Access Compliance Report

Public Rights-of-Way

(Curb Ramps)

Intersection ID: 7012	Main Street: HUTCHISON-MCDONALD_RD	Cross Street: LYNCH_DR	Location: S
ADA ID: 666E013E05F4	Ramp Type: Perp	Initial Pass/Fail: Fail	Overall Compliance: No
Severity Score: 16.25			
Codes/Mitigation Info/Possible Solution		Field Measurements/Component Compliance

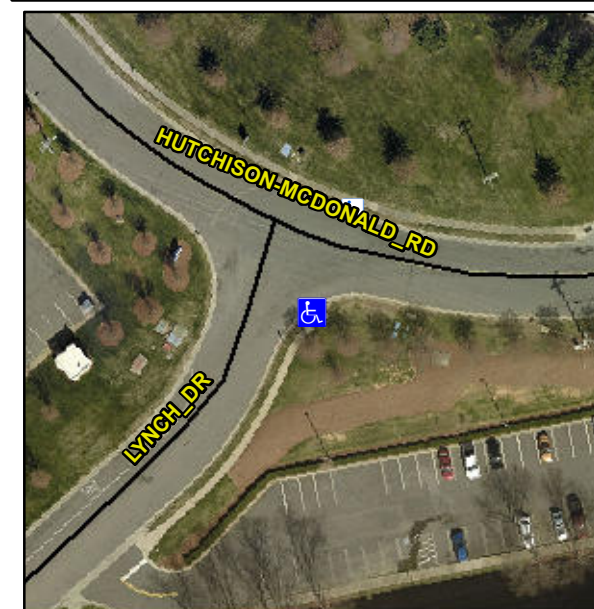
Not Found, R304.5.3, R302.7

Compliance	Description	Data	Compliance	Description	Data
N/A	Ramp Length (in)	46.0	Yes	Ramp Slope (%)	6.3
Yes	Ramp Width (in)	48.0	No	Ramp XSlope (%)	2.5
N/A	Flare Type LT	N/A	N/A	Flare Type RT	N/A
N/A	Flare Slope LT (%)	N/A	N/A	Flare Slope RT (%)	N/A
N/A	Flare Traversable LT?	N/A	N/A	Flare Traversable RT?	N/A
N/A	Landing Length (in)	N/A	N/A	DWS Provided?	N/A
N/A	Landing Width (in)	N/A	N/A	DWS Contrast?	N/A
N/A	Landing Slope (%)	N/A	N/A	DWS Length (in)	N/A
N/A	Landing X Slope (%)	N/A	N/A	DWS Full Width?	N/A
N/A	Landing Curb? (Y/N)	N/A	N/A	DWS Offset (in)	N/A
N/A	Shared Landing?	N/A			
N/A	Gutter Ponding?	N/A	N/A	Gutter Slope (%)	N/A
N/A	Gutter Lip Ht (in)	N/A	N/A	Gutter X Slope (%)	N/A
N/A	Painted X Walk1?	No	N/A	Painted X Walk2?	N/A
	X Walk 1 Direction	To NE		X Walk 2 Direction	N/A
N/A	X Walk 1 Width (in)	N/A	N/A	X Walk 2 Width (in)	N/A
	X Walk 1 Slope (%)	0.4		X Walk 2 Slope (%)	N/A
	X Walk 1 X Slope (%)	2.1		X Walk 2 X Slope (%)	N/A

N/A	Ramp inside XWalk1?	N/A	N/A	Ramp inside XWalk2?	N/A
	Road Slope (%)	N/A	N/A	Clear Space?	N/A
	Road X Slope (%)	N/A	N/A	Clear Space to XWalk (in)	N/A
N/A	Any Obstructions?	N/A	N/A	Storm Grate/Utility Hazard?	N/A
	Obstruction Type			Storm Grate/Utility Type	
		N/A			N/A
		No		Surface Condition? (G/P)	Poor

Remove & Replace Entire Ramp.
